Project	IEEE 802.16 Broadband Wireless Access Working Group < http://ieee802.org/16 >	
Title	FAST_FEEDBACK Channel Codeword Extension	
Date Submitted	2004-06-25	
Source(s)	Myung-Kwang Byun, Seungjoo Maeng, Jaeho Jeon, Soonyoung Yoon, Panyuh Joo	mk.byun@samsung.com
	Samsung Electronics Co., Ltd. Dong Suwon P.O.Box 105 416, Maetan-3dong, Yeongtong-gu, Suwon-city, Gyeonggi-do, Korea 442-600	
Re:		
Abstract	FAST_FEEDBACK Channel Codeword Extension	
Purpose	Adopting of proposed method into P802.16e	
Notice	This document has been prepared to assist IEEE 802.16. It is offered as a basis for discussion and is not binding on the contributing individual(s) or organization(s). The material in this document is subject to change in form and content after further study. The contributor(s) reserve(s) the right to add, amend or withdraw material contained herein.	
Release	The contributor grants a free, irrevocable license to the IEEE to incorporate material contained in this contribution, and any modifications thereof, in the creation of an IEEE Standards publication; to copyright in the IEEE's name any IEEE Standards publication even though it may include portions of this contribution; and at the

Figure bb1—Subcarrier Mapping of FAST_FEEDBACK Modulation Symbols for PUSC

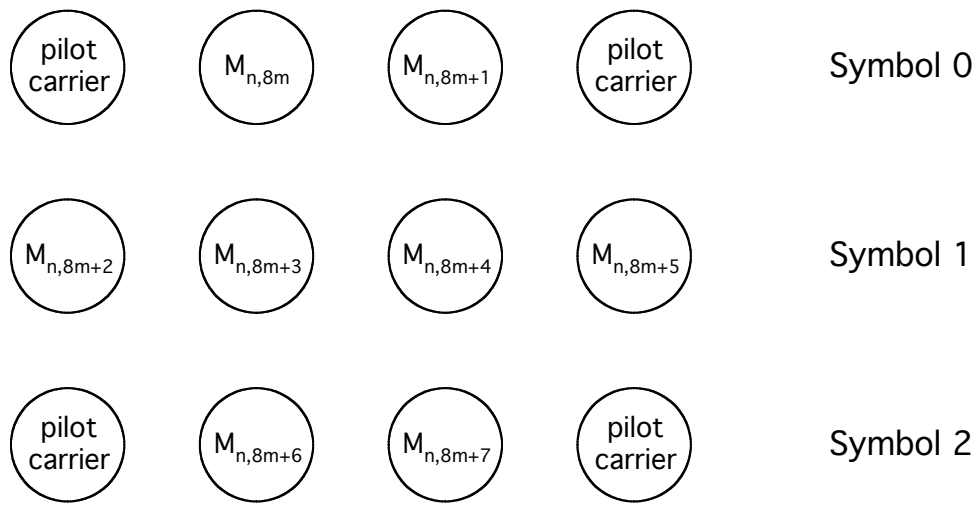
$M_{n,8m+k}$ is mapped to FAST_FEEDBACK channel tile as shown in Figure bb1 for PUSC uplink subchannel and in Figure bb2 for optional PUSC uplink subchannel. A FAST_FEEDBACK channel is mapped to one subchannel composed of 6 tiles.

Figure cc—Mapping of MIMO coefficients for fast MIMO feedback payload bits

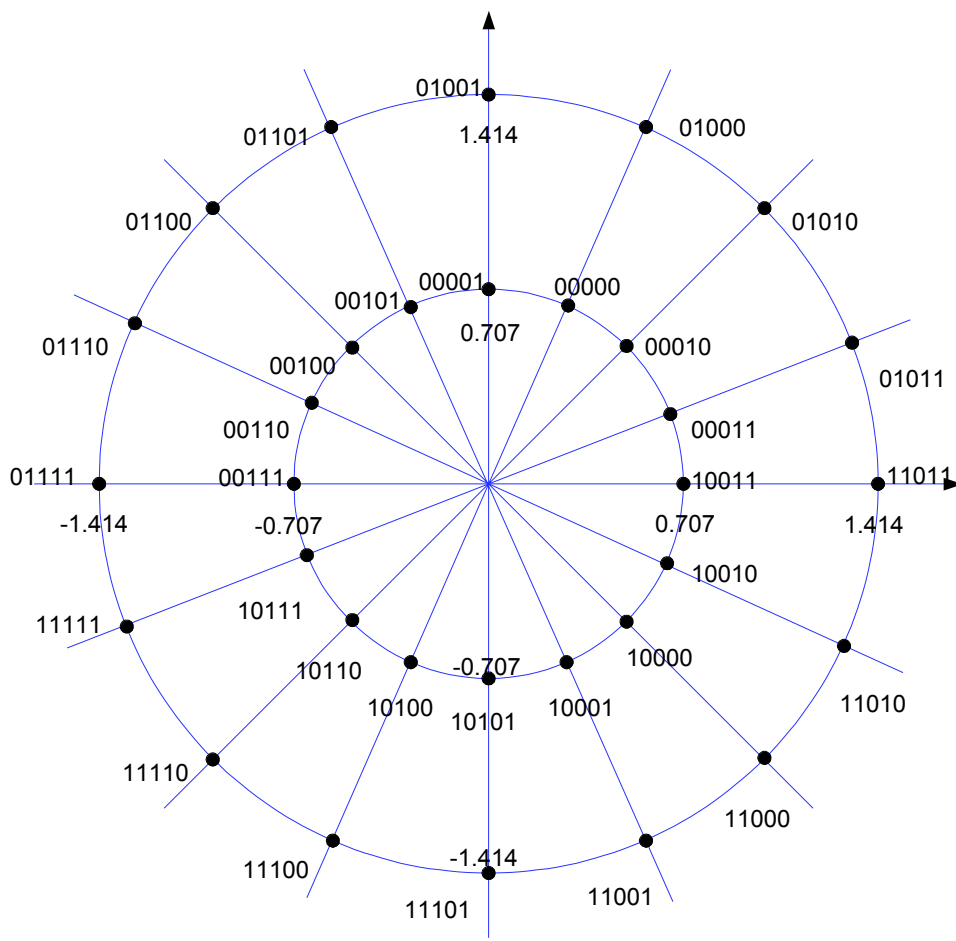
When the FAST_FEEDBACK subheader Feedback Type field is ‘01’ or ‘10’ the SS shall report the MIMO coefficient the BS should use for best DL reception (see 8.4.8.1.6). The mapping for the complex weights is shown in Figure cc.
